SUNDRY NOTICES AND REPORTS ON WELLS

1. oil well ☐ gas well ☒ other ☐
2. NAME OF OPERATOR
Northwest Pipeline Corporation
3. ADDRESS OF OPERATOR
P.O. Box 90, Farmington, New Mexico 87401
4. LOCATION OF WELL (REPORT LOCATION CLEARLY. See space 17 below.)
AT SURFACE: 945' FSL & 1185' FEL
AT TOP PROD. INTERVAL:
AT TOTAL DEPTH:

5. LEASE
SF 079033
6. IF INDIAN, ALLOTTEE OR TRIBE NAME
7. UNIT AGREEMENT NAME
San Juan 29-5 Unit
8. FARM OR LEASE NAME
San Juan 29-5 Unit
9. WELL NO.
94
10. FIELD OR WILDCAT NAME
Gobernador Pictured Cliffs
11. SEC., T., R., M., OR BLK. AND SURVEY OR AREA
Sec 23 T29N R5W
12. COUNTY OR PARISH
Rio Arriba
13. STATE
New Mexico
14. API NO.
15. ELEVATIONS (SHOW DF, KDB, AND WD)
6922'

NEW MEXICO OIL CONSERVATION COMMISSION
WELL LOCATION AND ACREAGE DEDICATION PLAT

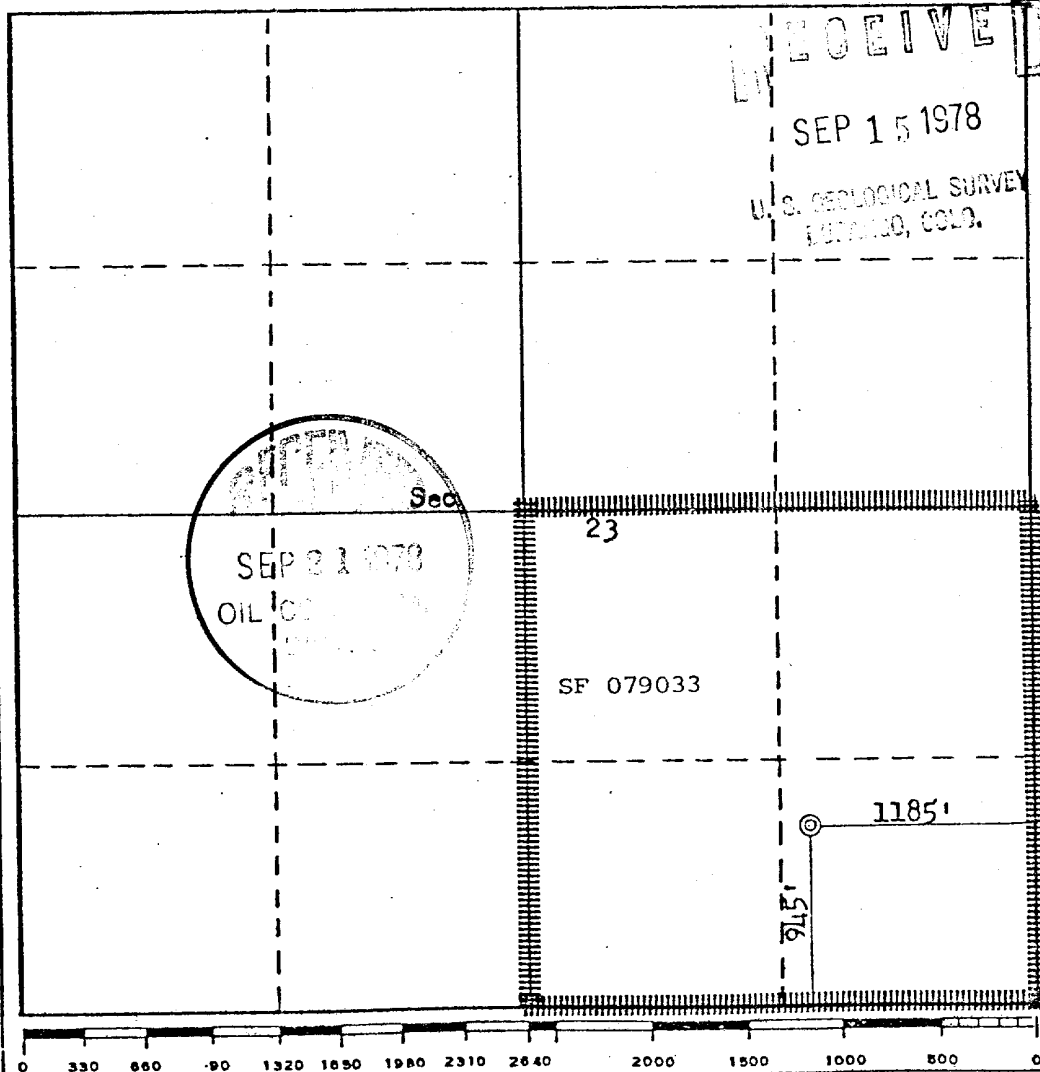
The location of this well has been changed:

Old location: 1020' FSL & 1170' FEL
New location: 945' FSL & 1185' FEL

Vicinity Map for
NORTHWEST PIPELINE CORP. #94 SAN JUAN 29-5 UNIT
945' FSL 1185' FEL Sec 23-T29N-R5W
RIO ARriba COUNTY, NEW MEXICO

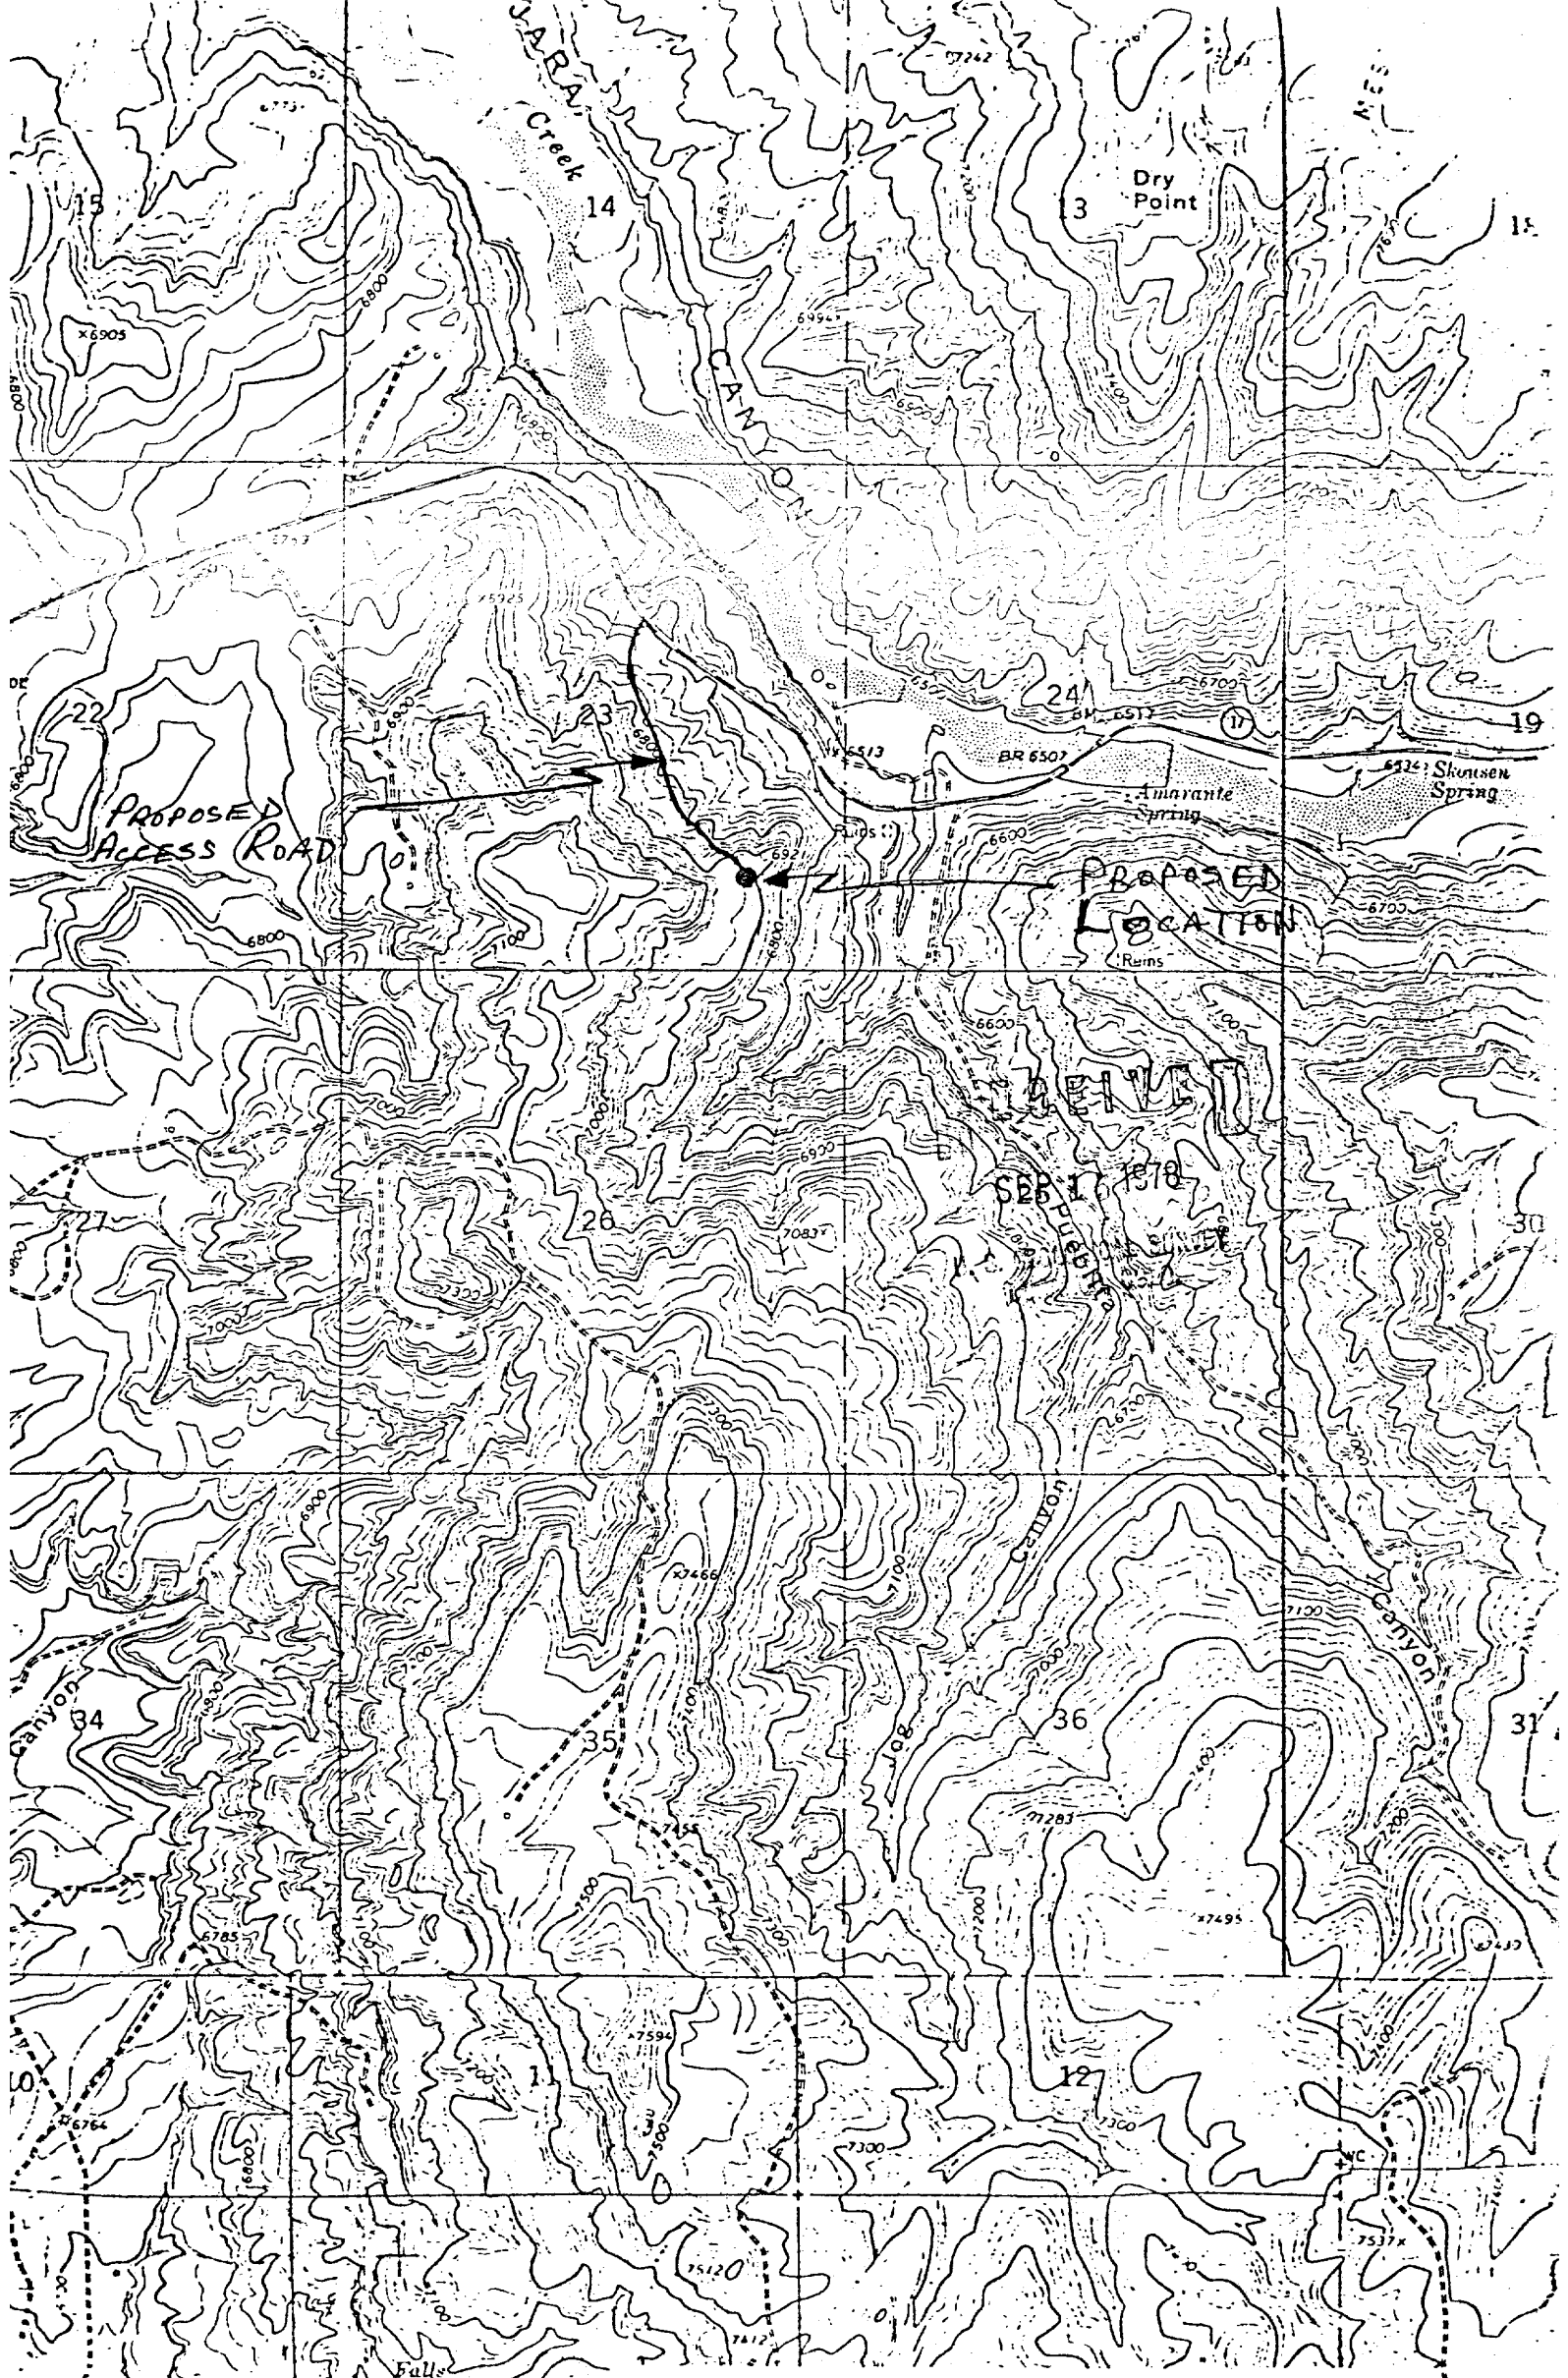
The proposed access road has been changed as shown on the attached Vicinity Map.
